Accessibility Survey

City of Downey Metro Street - Sideview Drive to True Avenue

Date of Inspection
6/16/2017

Prepared By
Disability Access Consultants
(800) 743-7067

Change in Level East of Songfest Drive @ 33.949944974953, -118.099225312471

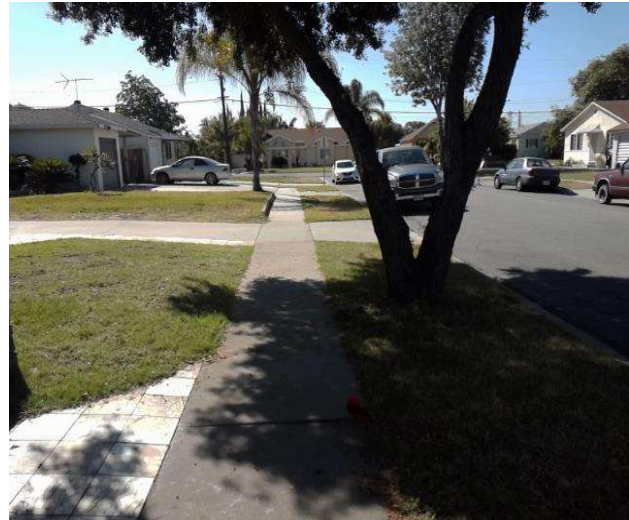
Sidewalks , Change in Level : Change in Level Non Beveled

Finding

There is a change in elevation greater than recommended value.

On-Site Finding 1.00 inches

Ensure that the change in elevation is within the recommended value.

Recommendation Up to 0.25 inches
